HISTORY OF BRIAN WAITKUS OBJECTIONS/COMPLAINTS TO PERMITS

Mountain Cement Company Exhibits  
EQC Docket No. 13-407  
LQD Permit No. 298C-A7; TFN 5 1/110  
MCC-10

**RE: Mountain Cement Company, TFN 3 4/70, Docket No. 2826-97**

The following comments are in response to Mountain Cement Company's submission for public notice their proposal to mine Amendment 298C-A7 of mine permit 298c

Figure 1. Sand filled fracture exposed at the present surface and now in the wall of Etchepare 7A east of Area "C"

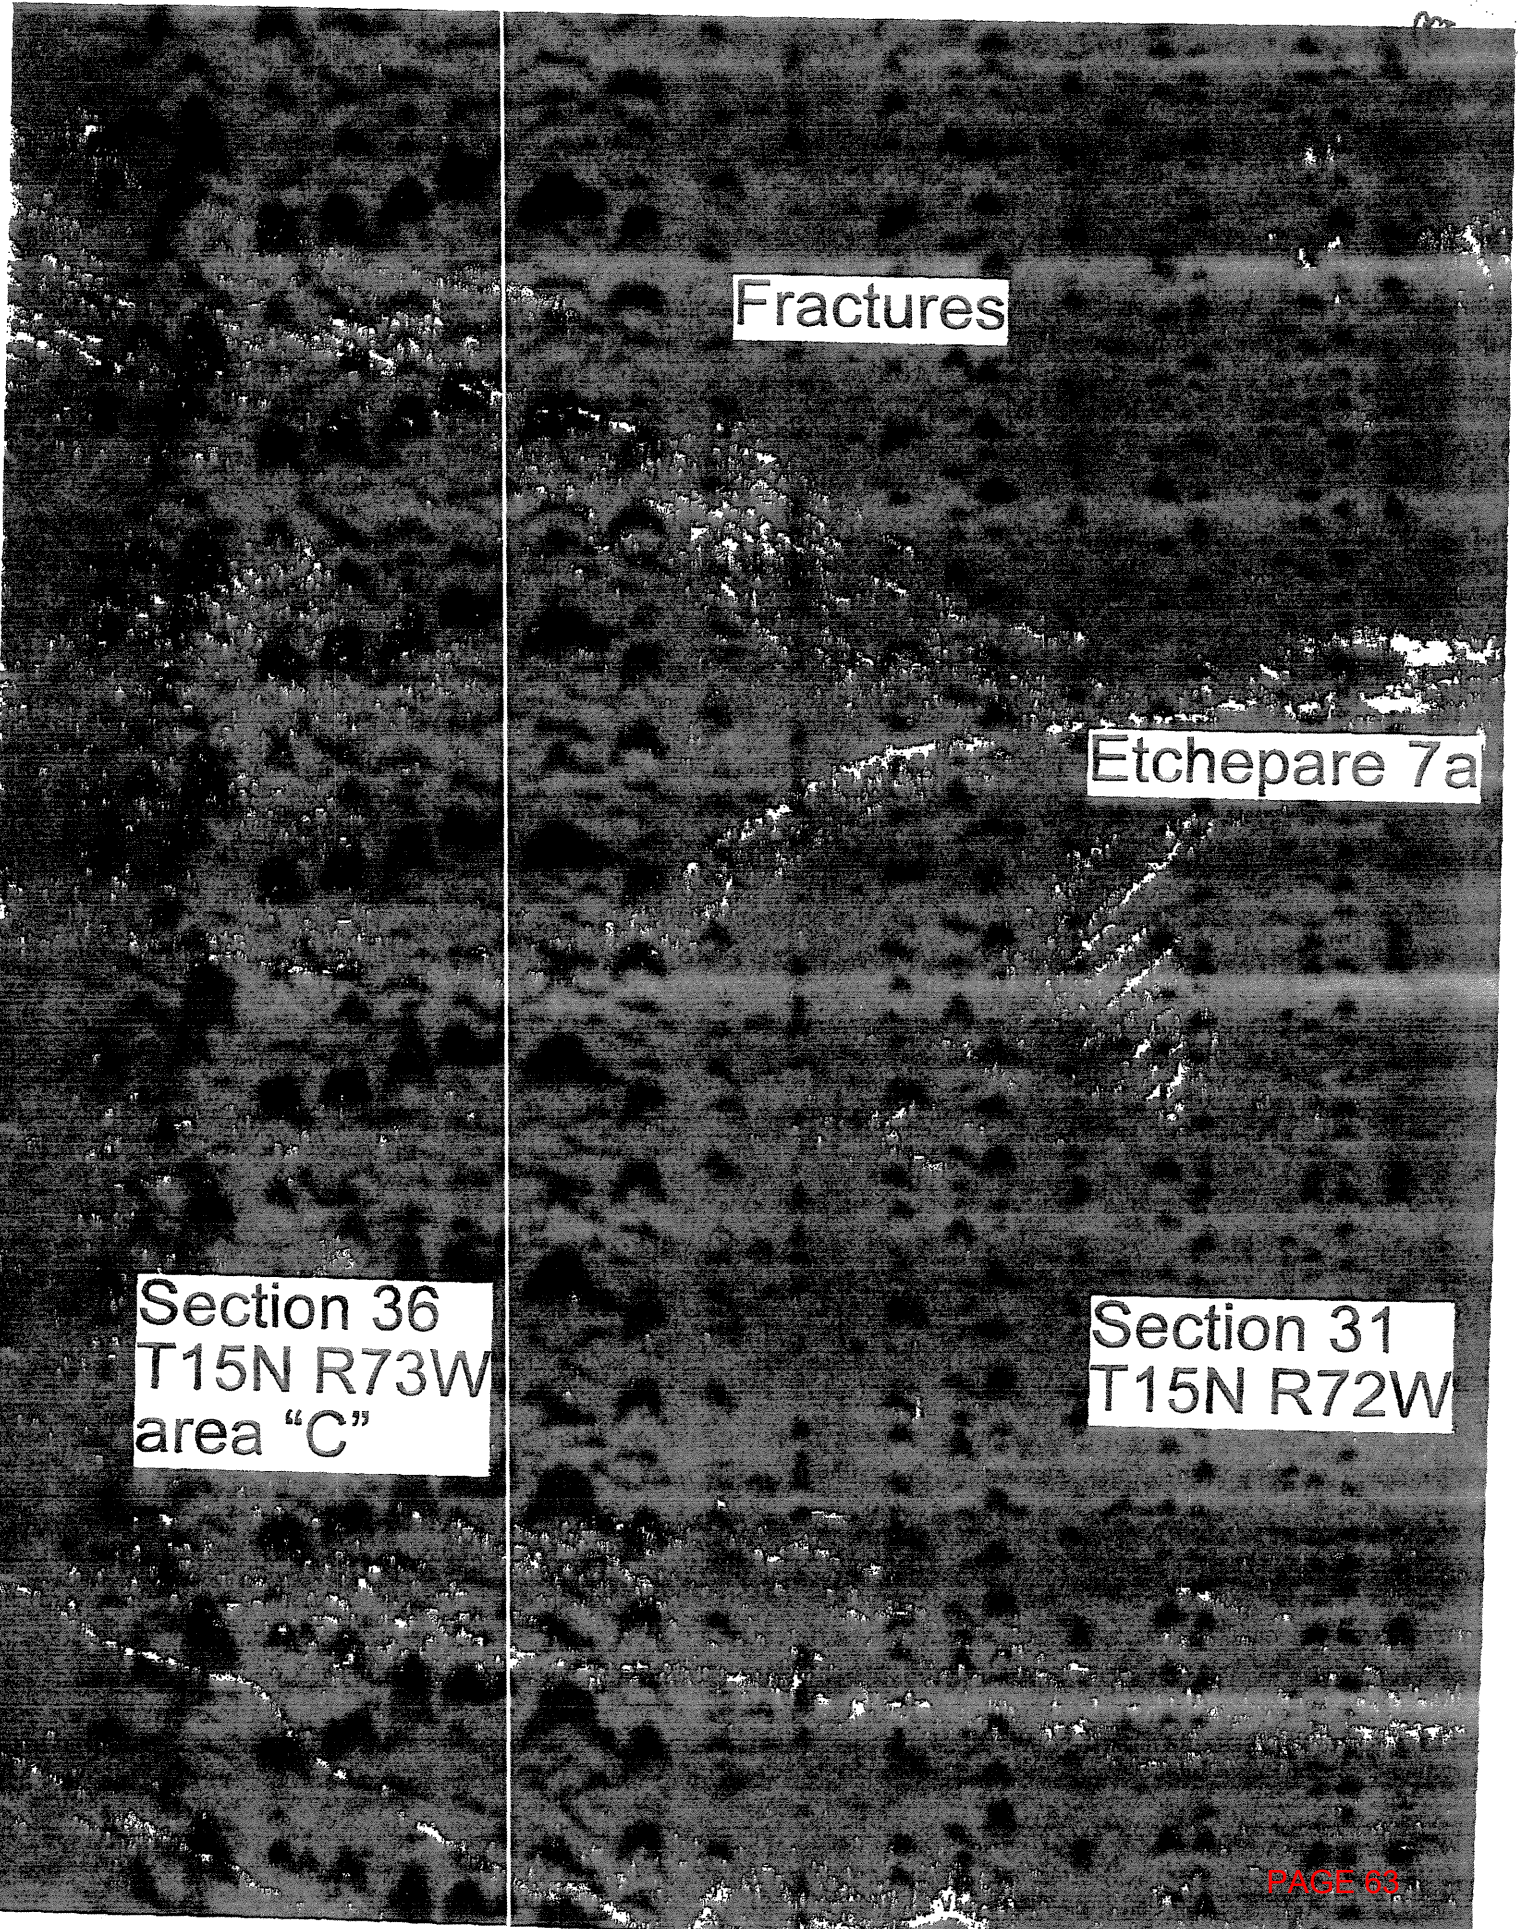
13. DVIII6 Hydrology. Map DVIII6-M3 shows three drainages in Area "C": 1. Un-named drainage on the north side of area, 2. E12 drainage running east-west in the center of area "C", 3. E9 drainage along the south side. Map MPVIII-M1 shows two mining areas in area "C". The northern one is located between the un-named drainage and drainage E12. The southern mine area is located between E12 and E9 drainages. DVIII6-1 states that "*Ephemeral drainages (E12) and (E9) bound the mining area on the north and south sides*". This plan has many inconsistencies such as this one and they should be corrected before allowing the mining of this area to precede.

It is stated that "*The primary channels associated with quarry (E9 and E12) will not be affected or modified during mining activities.*" Map RPVIII-2 indicates a sediment control pond will be built at the west end of the E12 drainage in area "C". This would suggest this portion of the drainage will be affected. Is the statement or the map correct?
